Village of Arlington Heights  
Conceptual Plan Review Committee  
Virtual Meeting  
December 2, 2020  
7:00 PM

- A. Rohrman Auto Mall - NEC Wilke Rd/Dundee Rd. - T1713  
PUD Amendment, Resubdivision, Rezoning Lot 3

# **VILLAGE OF ARLINGTON HEIGHTS** **STAFF DEVELOPMENT** **COMMITTEE REPORT**

**Temp File Number:** T1713  
**Project Title:** Rohrman Auto Mall PUD Amnd.  
**Location:** 1100,1400 W. Dundee Rd. and 1510-1530 W. Dundee Rd.  
**PIN:** 03-06-302-020 through -024

# FINAL PLAT OF BOB ROHRMAN'S ARLINGTON HEIGHTS AUTO MALL

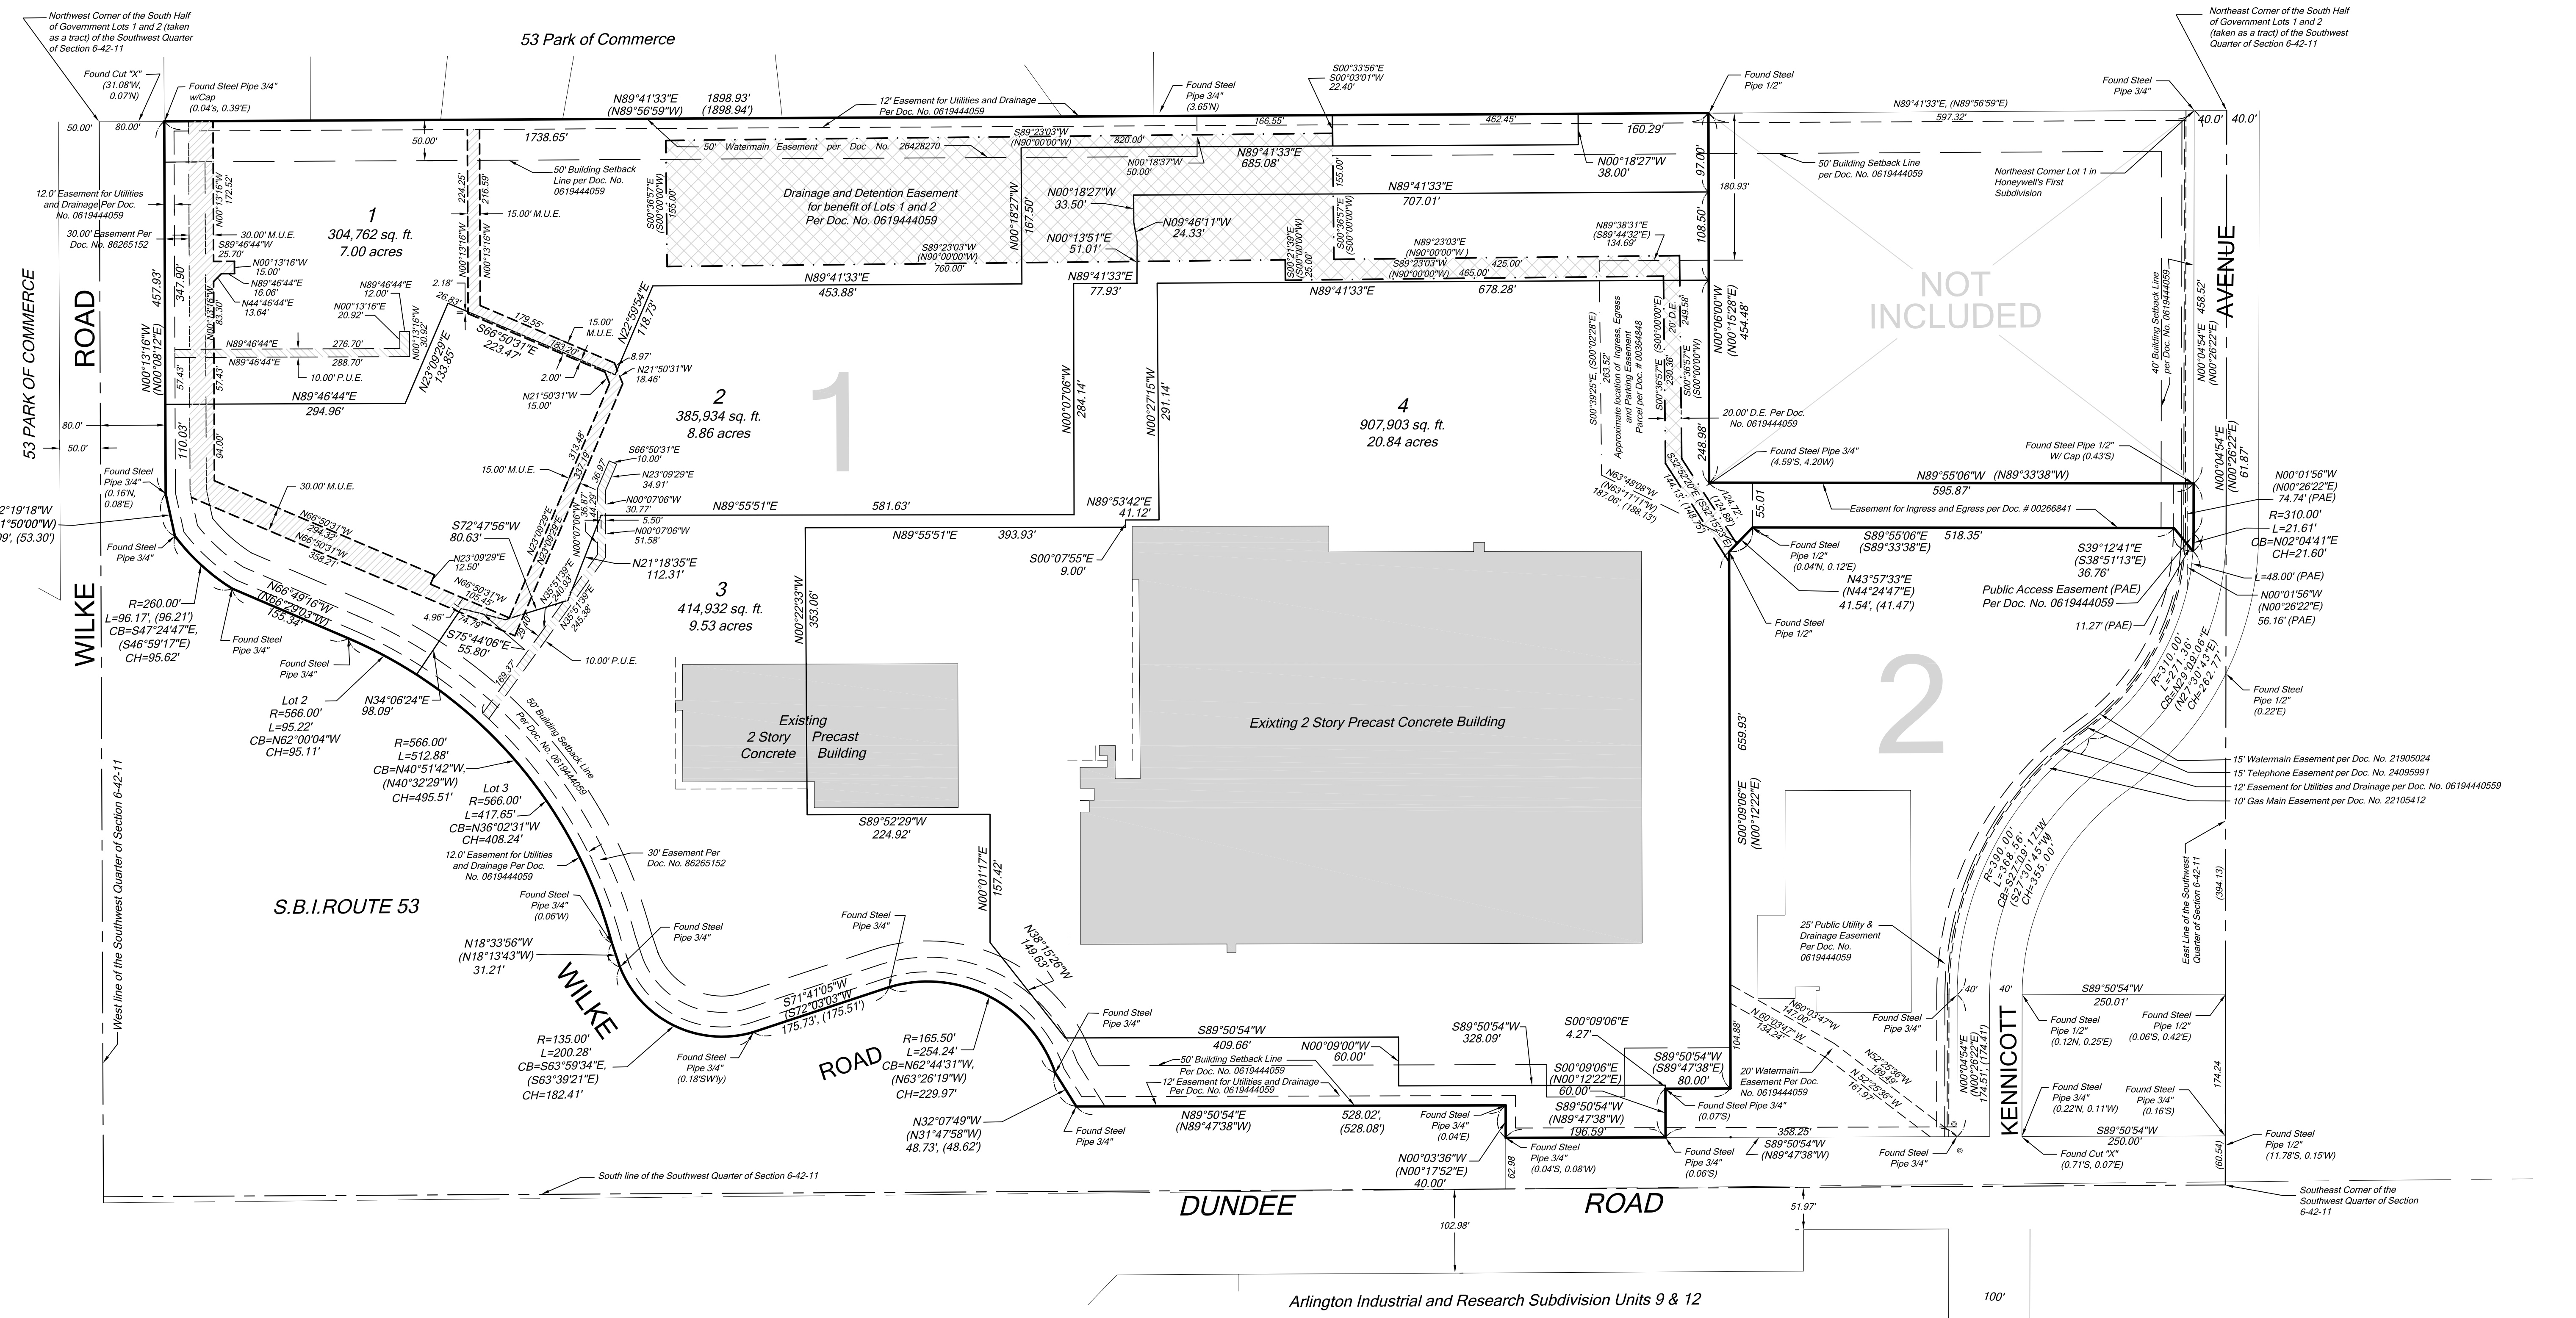
- **The variance requested is the minimum variance necessary to allow reasonable use of the property.**
2. Petitioner shall explore the possibility for increased frontage on Wilke Road for Lot 1.

4. Petitioner shall verify that all previously required easements were established as required, and shall analyze if any adjustments to the cross access easements are necessary as a result of the proposed resubdivision.

PROJECT NUMBER  
PEAS-18094-3  
SHEET TITLE  
PROPOSED  
DEMOLITION PLAN

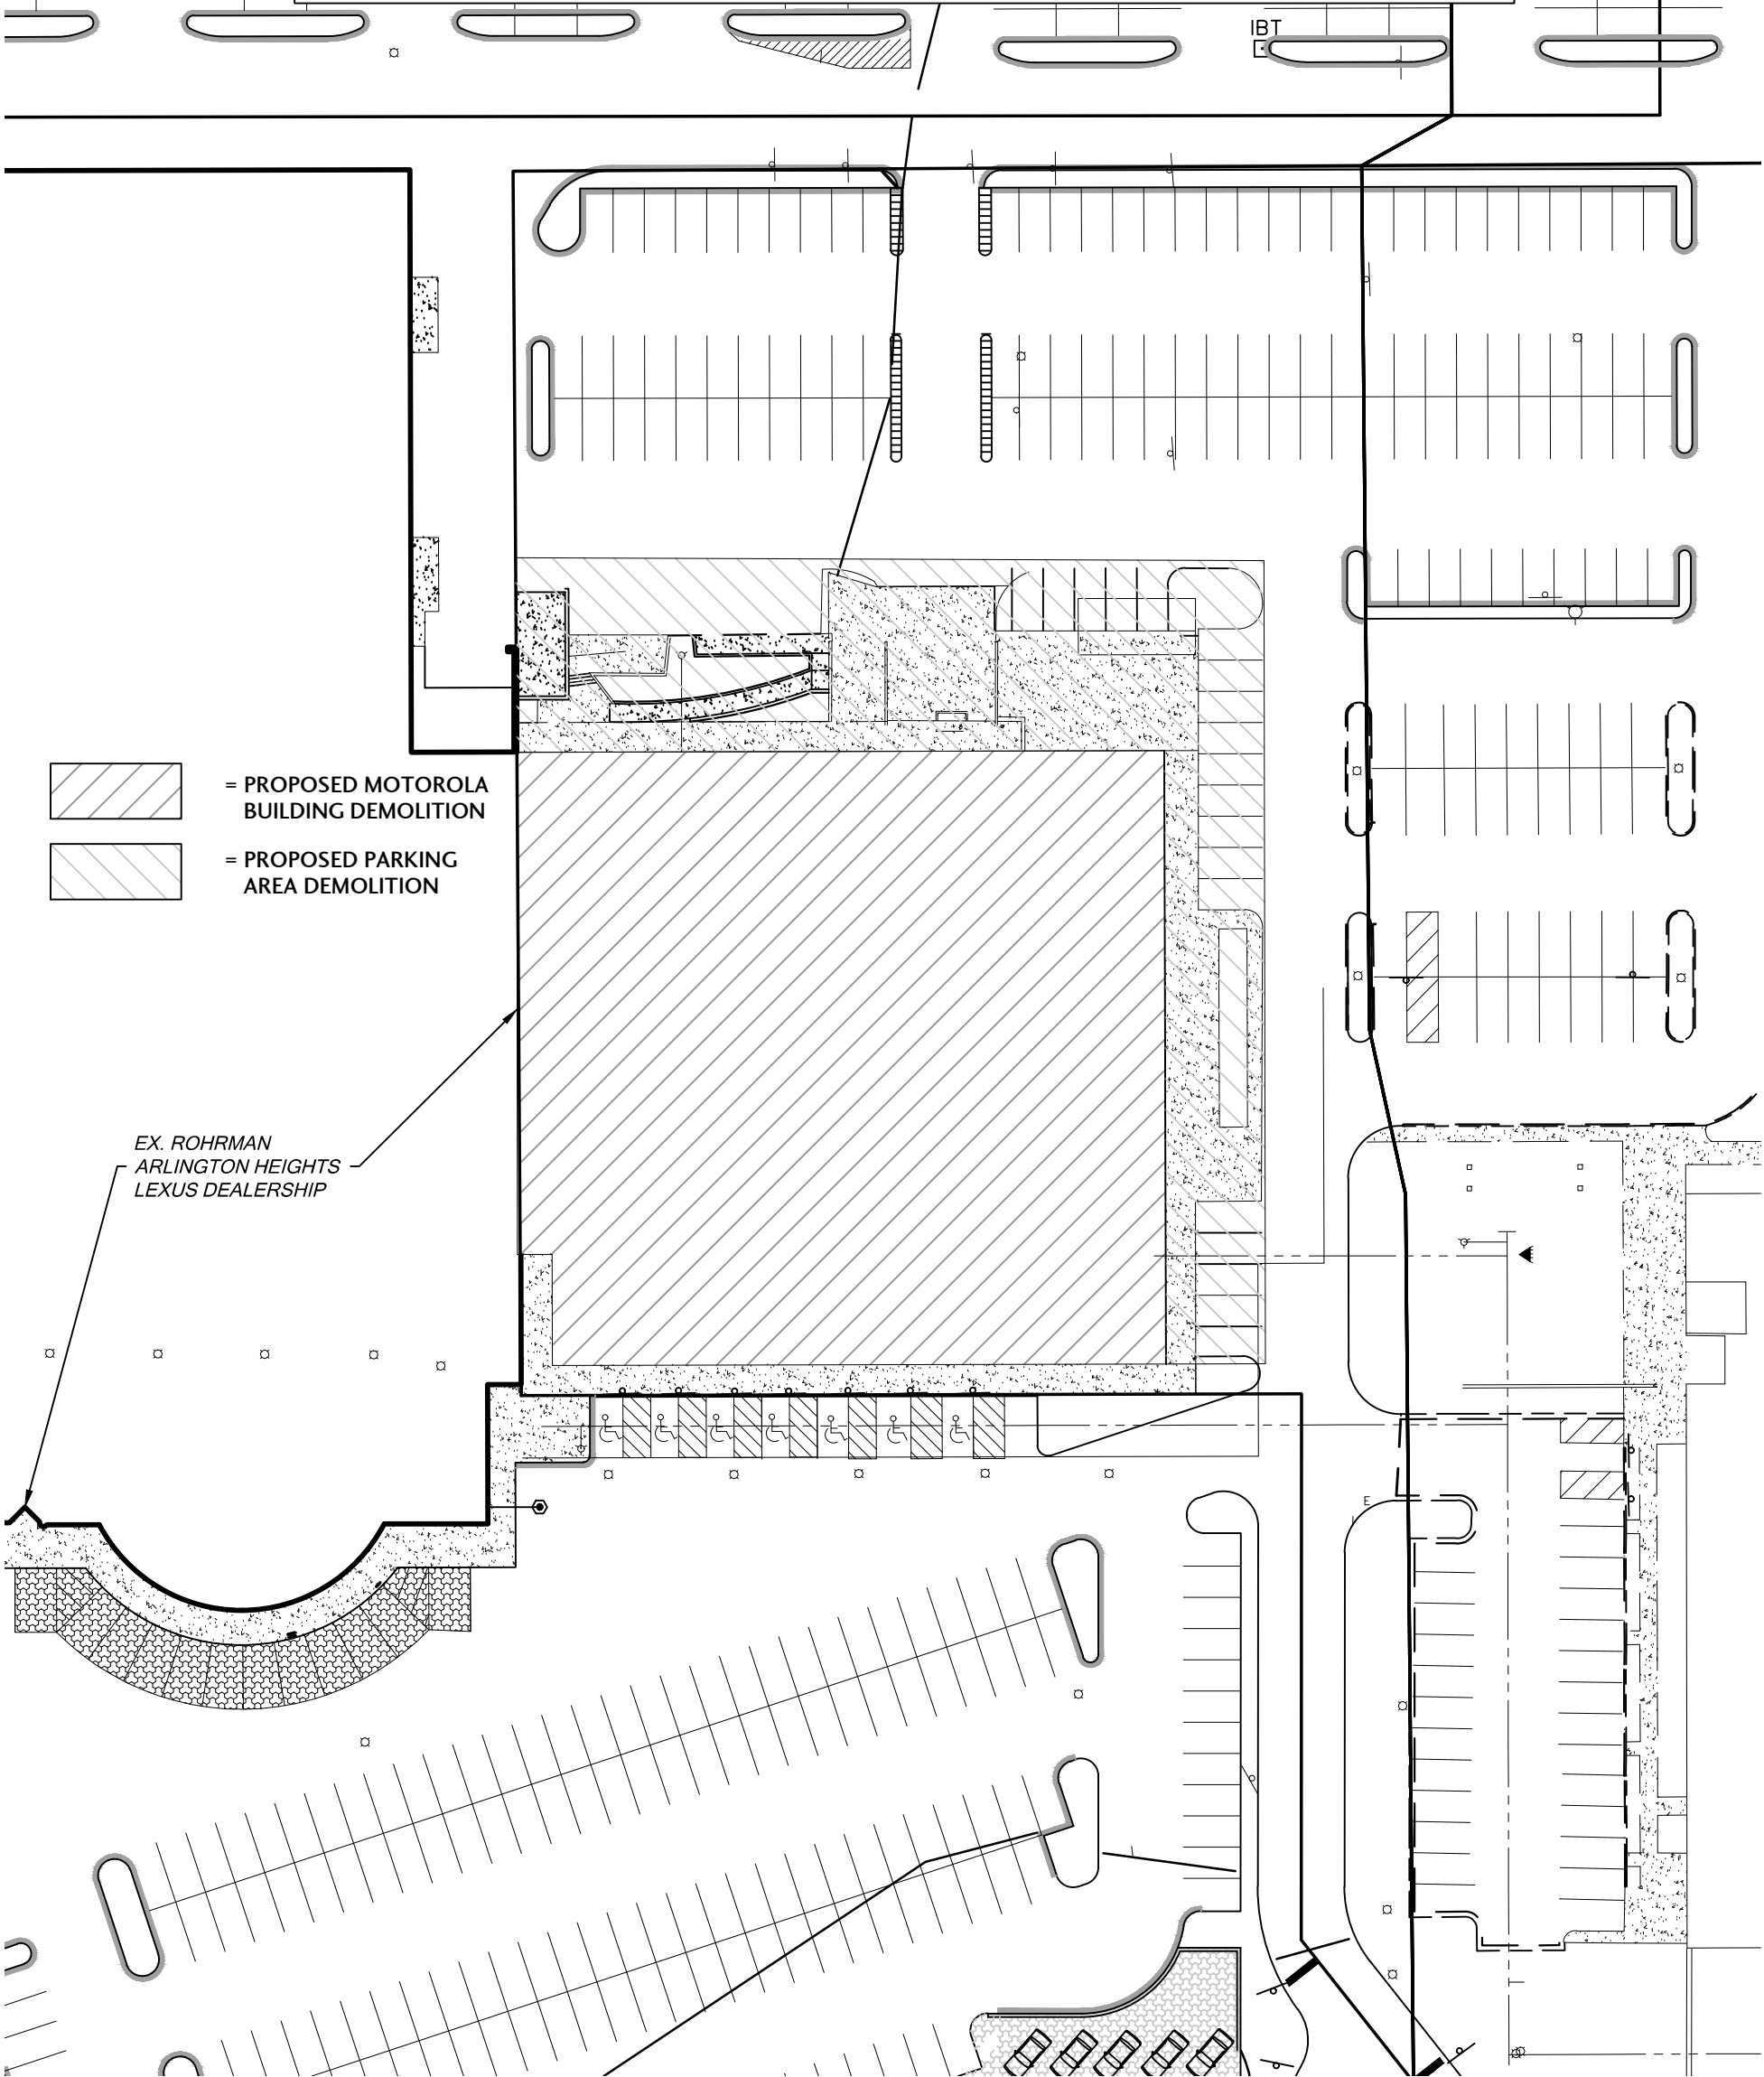
The petitioner is not proposing the construction of any new structures at this time. However, in the place of the demolished “Motorola” building, the petitioner has proposed approximately 166 parking stalls. Detailed geometric plans shall be required, and all proposed parking rows shall be designed to adequately integrate with the existing parking rows and drive aisles on the site. A code compliant landscape and photometric plan shall be required.

Preliminary review indicates that an MWRD permit will be required, and the parking lot work must conform to all Village and MWRD stormwater management regulations. The petitioner must provide fire truck turning radius exhibits to show fire apparatus circulation through the parking lot. Elevations of the exposed building materials have been submitted to staff and are under review to determine if a formal Design Commission application will be required.
